Macquarie Park Commerce Centre

Architectural Design Statement S10758 September 2010

Concept Plan Response to Submissions (July 2011)

Masterplan Evolution

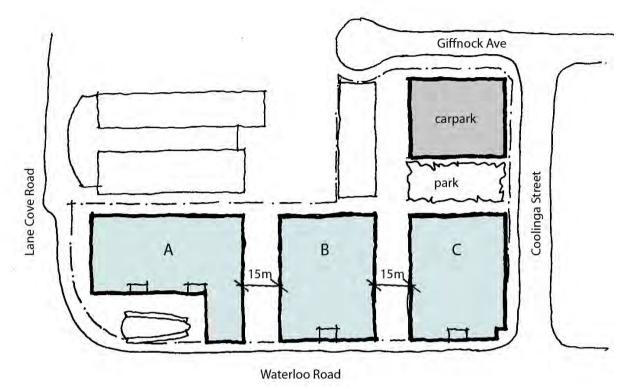
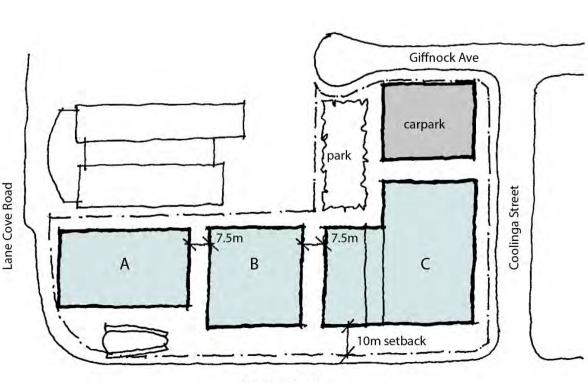
-Options for varying the footprint and separation of Buildings B, C and D to generate a more diversely designed streetscape, particularly at the corner of Waterloo Road and Coolinga Street, should be provided. In respect to Buildings B and C, clarification is required regarding the proposed connection between these buildings and the potential impact upon the use and circulation patterns at ground level and the streetscape of Coolinga Street.

-The smaller buildings have a very similar building form, footprint and separation along Waterloo Road. Whilst this is generally consistent with the DCP there is an opportunity to create a more dynamic group of buildings by varying the footprint and separation. This could also assist in providing different character to the landscape areas between the buildings.

>buildings flush along Waterloo Road boundary
>above ground carpark building to south of site
>small park, it's location has compromised solar access from adjacent buildings

- a. restrictive pedestrian zone along Waterloo Road frontage
- b. small park with compromised access to northern light
- c. unviable building A footprint that infringes on station plaza
- d. limited exposure along Coolinga Street

- >Increased commercial frontage along Coolinga Street.
- >Increase setback to station plaza.
- >above ground carpark building to south of site
- >reduced building depth to create large park at rear
- >reduced building depth results in reduced building separation to achieve sqm.

- a. reduced amenity with 7.5m building separation
- b. large, inflexible footprint to Building C
- c. minimal separation between carpark and building C

>introduce 10m setback along Waterloo Road for Civic Plaza >above ground carpark building to south of site >reduced size of park

a. reduced amenity to occupants with 7.5m building separation

Masterplan Evolution

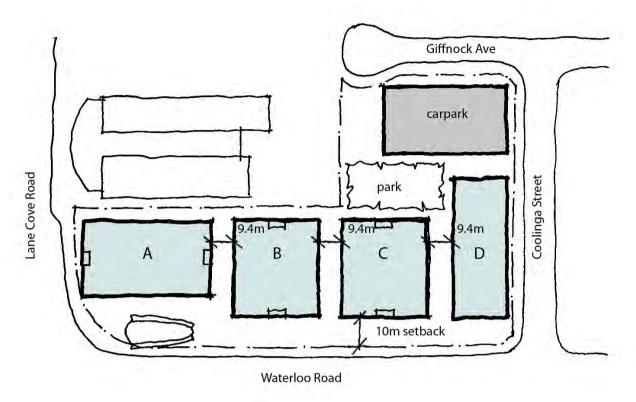
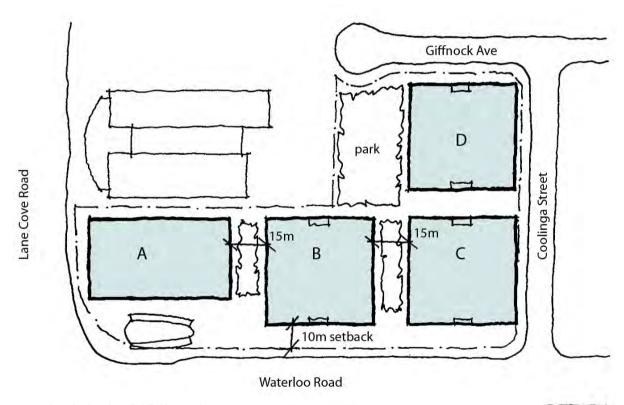
-Options for varying the footprint and separation of Buildings B, C and D to generate a more diversely designed streetscape, particularly at the corner of Waterloo Road and Coolinga Street, should be provided. In respect to Buildings B and C, clarification is required regarding the proposed connection between these buildings and the potential impact upon the use and circulation patterns at ground level and the streetscape of Coolinga Street.

-The smaller buildings have a very similar building form, footprint and separation along Waterloo Road. Whilst this is generally consistent with the DCP there is an opportunity to create a more dynamic group of buildings by varying the footprint and separation. This could also assist in providing different character to the landscape areas between the buildings.

>retain 10m setback along Waterloo Road for Civic Plaza >above ground carpark building to south of site >5 buildings tested for commercial viability >reduced building separation to enable 4 buildings of viable floorplates along Waterloo Road frontage

Undesirable design characteristics: a. above grade multi- storey carpark b. limited exposure along Coolinga Street

>retain 10m setback along Waterloo Road for Civic Plaza >maximise commercial frontage along Coolinga Street >above ground carpark building to south of site deleted >large park at rear overlooked by buildings B,C & D. >increased building separation to achieve pocket parks between buildings

The current proposal displays the best urban design outcomes of the previous studies. This proposal displays significant public benefit through suitable building separation; boundary setbacks; appropriate station plaza and civic plaza setbacks; street alignment; size and orientation of landscape and park areas for public amenity. The proposal also creates flexible, open commercial floorplates sizes for prospective tenants. This masterplan was therefore taken forward in the concept plan application.

Streetscape Studies

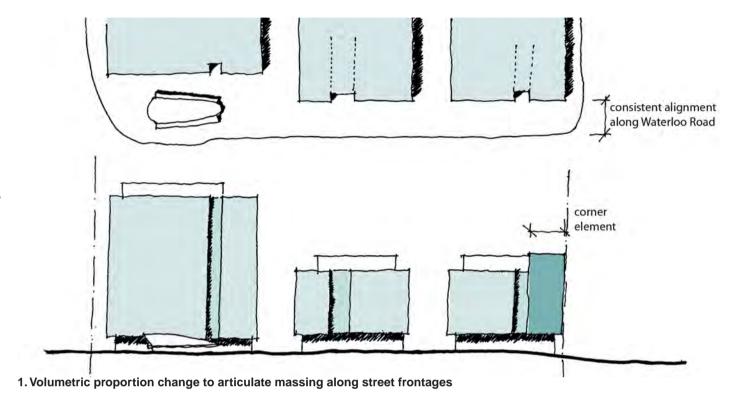
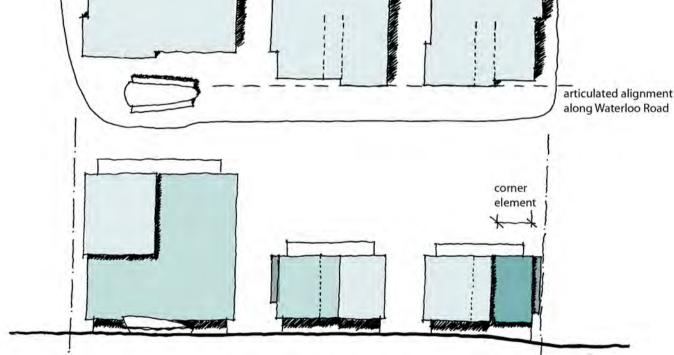
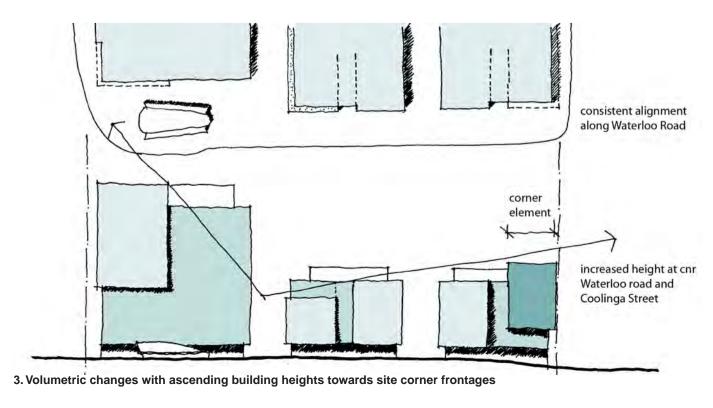
-Options for varying the footprint and separation of Buildings B, C and D to generate a more diversely designed streetscape, particularly at the corner of Waterloo Road and Coolinga Street, should be provided. In respect to Buildings B and C, clarification is required regarding the proposed connection between these buildings and the potential impact upon the use and circulation patterns at ground level and the streetscape of Coolinga Street.

-The smaller buildings have a very similar building form, footprint and separation along Waterloo Road. Whilst this is generally consistent with the DCP there is an opportunity to create a more dynamic group of buildings by varying the footprint and separation. This could also assist in providing different character to the landscape areas between the buildings.

Further to the previous study, using Study 5 as the accepted scheme in plan, we also anticipate each building envelope will be articulated through architectural expressions that respond to the above concerns raised in order to create a more diverse

The building form could be articulated within the approved building envelopes to create a variety of proportion through expressed volumes of the buildings. This could define the corners or gateways to the site, respond to scale of the Station Plaza to create individual massing to each building. The building alignment would be consistent to reinforce the objectives of the Macquarie Park Corridor DCP.

The buildings could be articulated through changes in setbacks and projections that articulate and diversify the streetscape and separation of building footprints. This would create individual character to each building and create more individual spaces within the public domain.

Although the alignment differs along the frontage the minimum setback is achieved and is consistent with the objectives of the Macquarie Park Corridor DCP.

Use of varying heights and massing of volumes could be articulated in a way that defines the prominent corners of the site or other public domain criteria.

Streetscape Studies

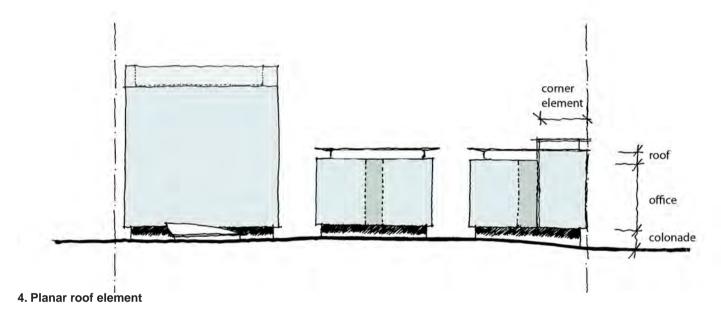
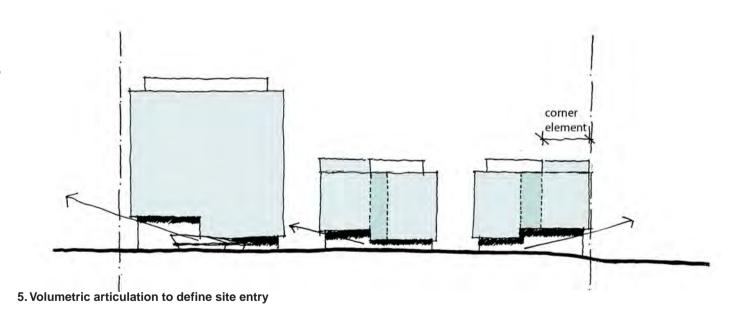
-Options for varying the footprint and separation of Buildings B, C and D to generate a more diversely designed streetscape, particularly at the corner of Waterloo Road and Coolinga Street, should be provided. In respect to Buildings B and C, clarification is required regarding the proposed connection between these buildings and the potential impact upon the use and circulation patterns at ground level and the streetscape of Coolinga Street.

-The smaller buildings have a very similar building form, footprint and separation along Waterloo Road. Whilst this is generally consistent with the DCP there is an opportunity to create a more dynamic group of buildings by varying the footprint and separation. This could also assist in providing different character to the landscape areas between the buildings.

The buildings could be articulated with roof expressions to integrate the plant and create a termination and scaling device for the top of the building.

Possibility to alter the height and volume within the colonnades at the gateway's to the site to define the entries to the site and diversify the streetscape.
